NOTICE OF DECISION

Meriwether Short Plat

Land Use Application Nos.:	SPL-21-001 (Short Plat) SEP 20-007 (SEPA)
Applicant:	N1C1 Holdings LLC PO Box 2198 Battleground, WA 98604
Property Owner:	Adrienne Carlson PO Box 2198 Battleground, WA 98604
Site Location:	At the end of Scott Hill Road and East Scott Avenue
Parcel & Size:	508890100, 4.8 Acres
Zoning Designation:	Low Density Residential (LDR-8.5)
Date Application Received:	January 5 th , 2021
Notice of Application & Likely DNS issued:	June 13 th , 2022 [see SEPA case # sep-20-007]
Comment Period & SEPA Appeal Period Ended:	June 28 th , 2022
Notice of Decision Issued:	September 30 th , 2022
DRC Decision:	Approve with Conditions

MERIWETHER SHORT PLAT

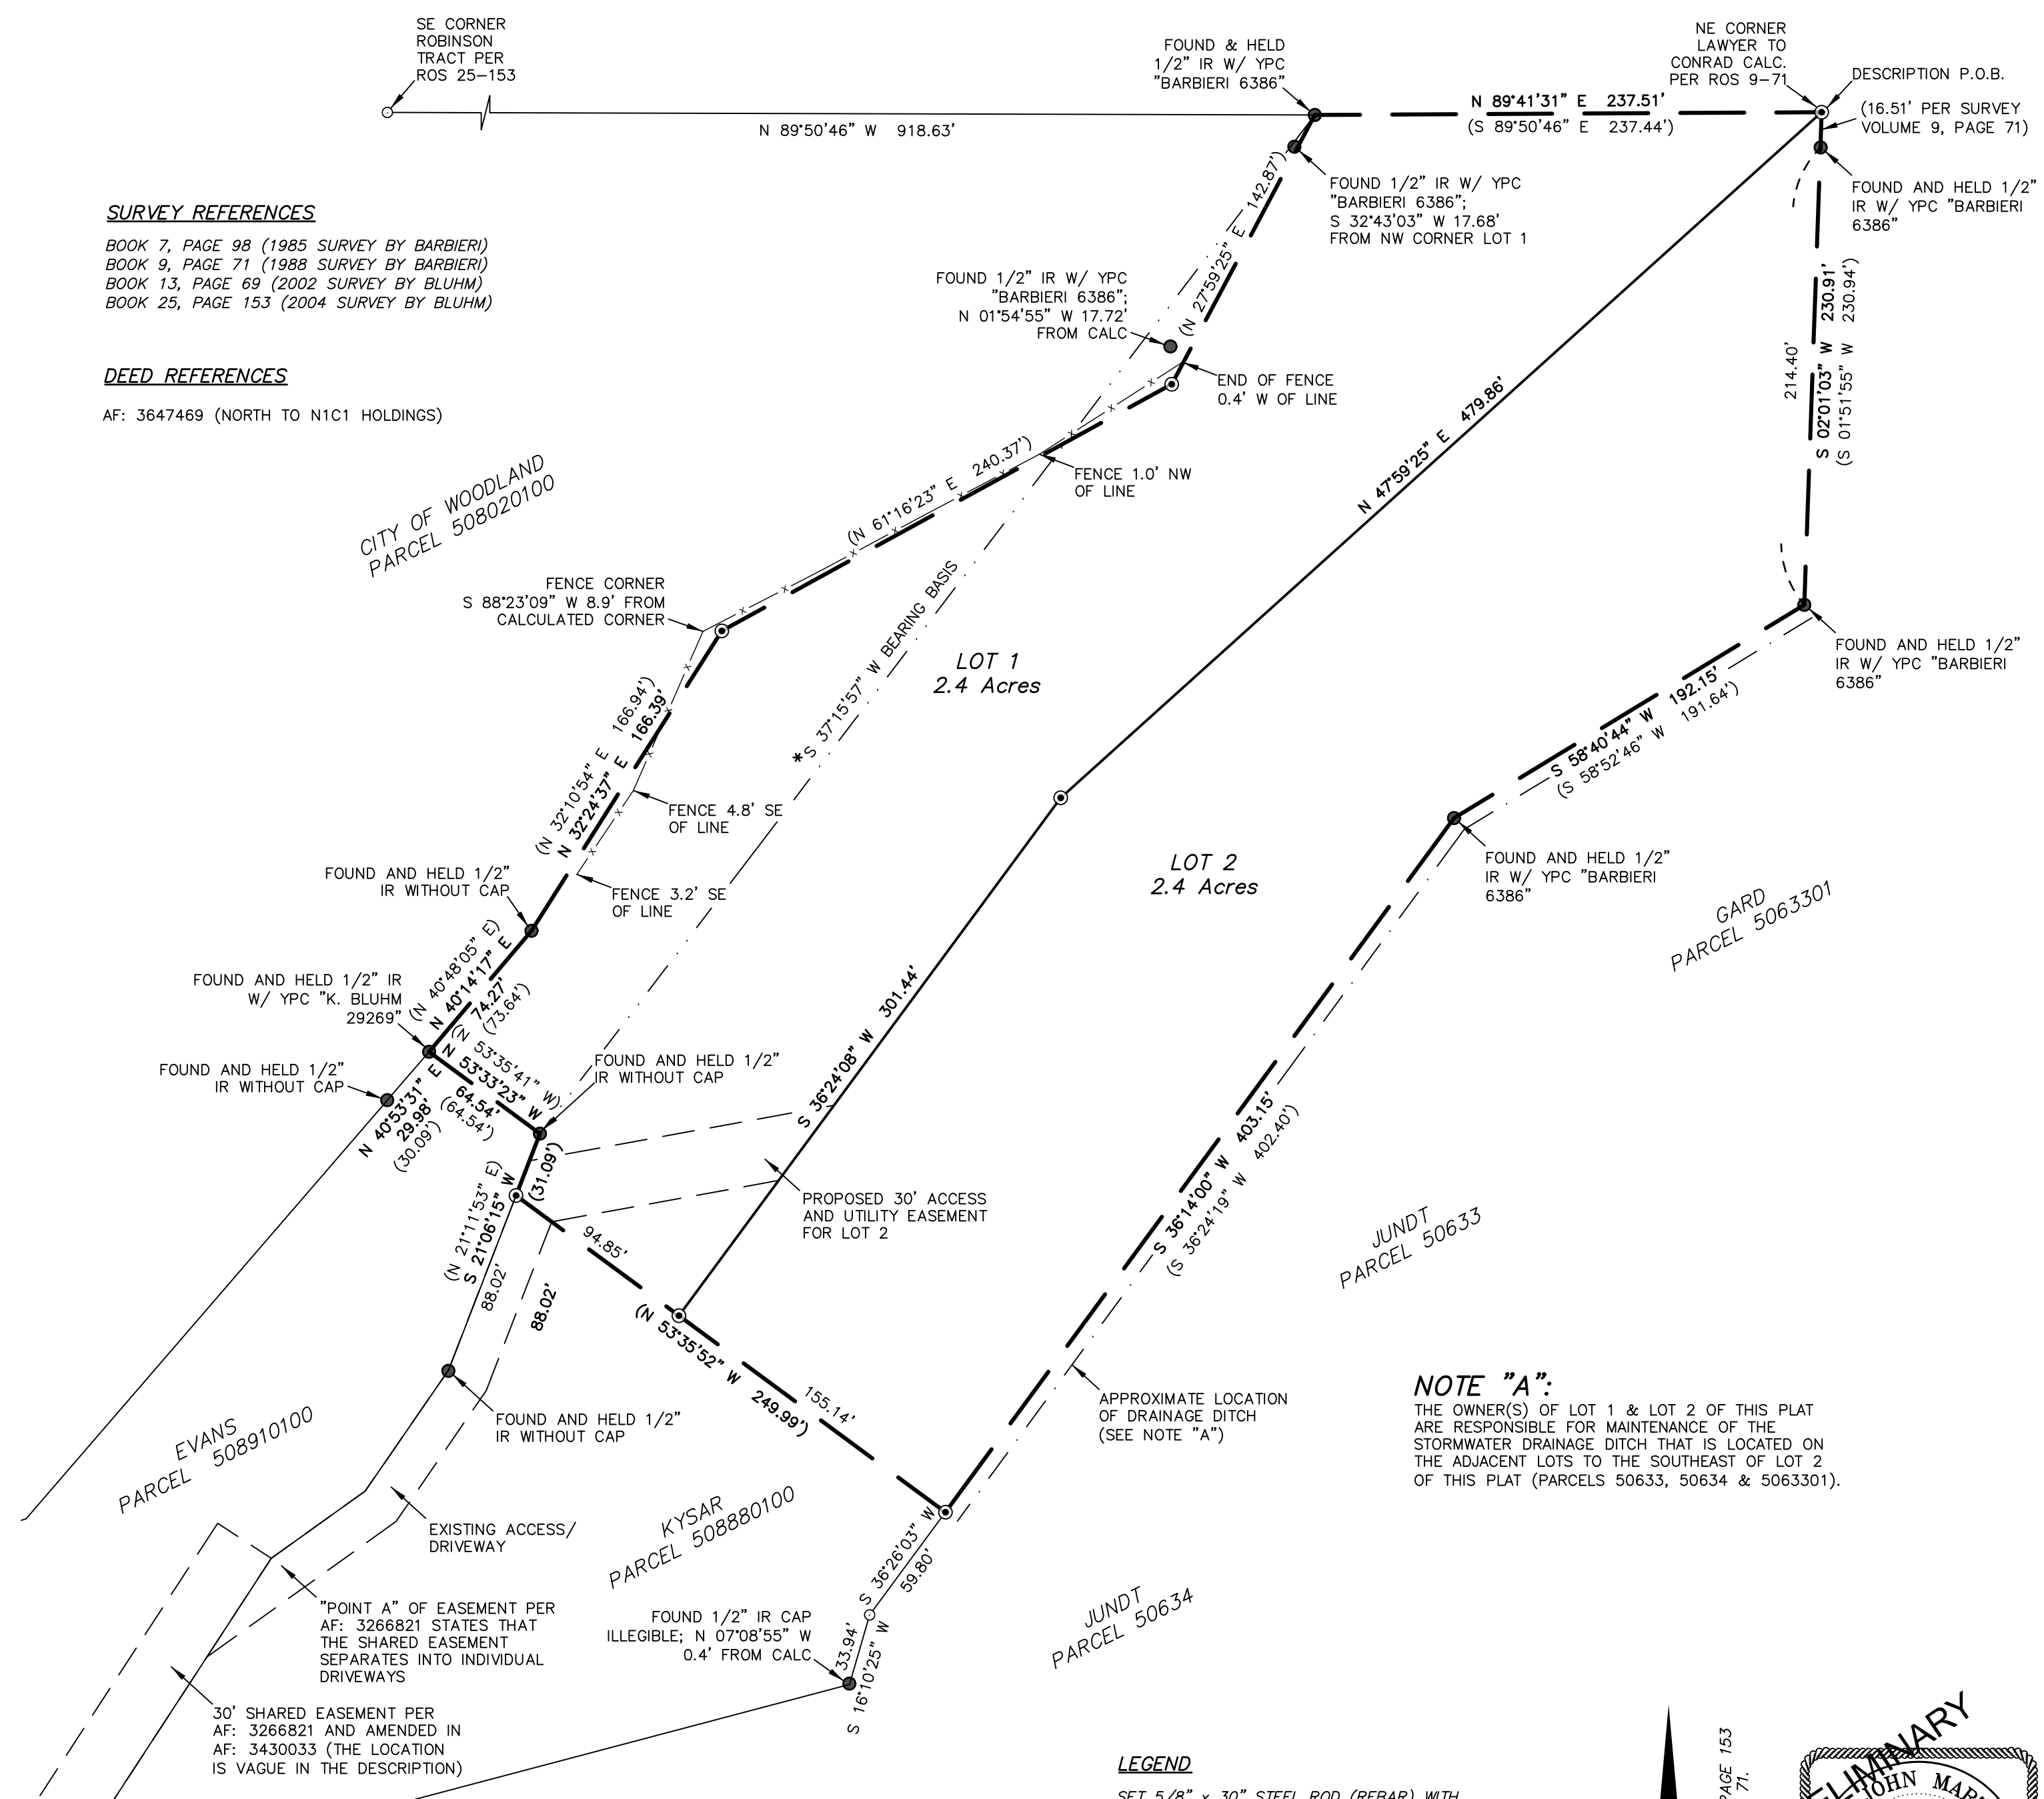
Finding 6: The access and utility easement terminates at the point marked 'A' on provided plans, and driveways are proposed from that point. No current access or utility easements have been provided from "point A" to the boundary line of the proposed 'Lot 1' of the short subdivision. Applicant shall identify access and utility easement(s) permitting use of identified driveway/private road between point "A" and proposed "lot one."

Finding 7: Phillip Carlson, the applicant's representative, has provided confirmation that an informal access and utility easement has been in place between the applicant and Jonny Kysar, the owner of parcel 50880100 (labeled as 'Kysar parcel'). The existing driveway would adequately provide access to the property in question. A condition has been added that an access and utility easement shall be required to be filed with the Cowlitz County assessor's office prior to final plat approval and be provided to the City to ensure this informal easement is maintained in perpetuity. (*See Condition 7*)

Finding 9: Applicant has proposed a 30-foot access and utility easement across the southeast corner of proposed 'lot 1' to serve as access to proposed "lot 2." All new easements and/or dedications associated with this short subdivision shall be recorded alongside the final plat. (*See Condition 9*)

Finding 13: The complainants requested that the applicant contact them to ensure maintenance of the drainage ditch be preserved and requested that a note be placed on the plat that the owner(s) of both lots of this plat are responsible for maintenance of the adjacent drainage ditch, which the applicant has provided. A condition of approval has been added that this note shall remain on the final plat. (*See Condition 13*)

6. Contact Clark County Fire and Rescue for hydrant locations and include on final plat.
7. Final plat must identify valid access and utility easement between "point A" and the property line/frontage of proposed "lot 1." Applicant is required to file an access and utility easement along the existing driveway prior to final plat approval.

13. Applicant shall ensure that the following notes are added and/or maintained on the final plat:
 - a. The owner(s) of Lot 1 & Lot 2 of this plat are responsible for maintenance of the stormwater drainage ditch that is located on the adjacent lots to the southeast of Lot 2 of this plat (Parcels 50633, 50634, & 5063301).
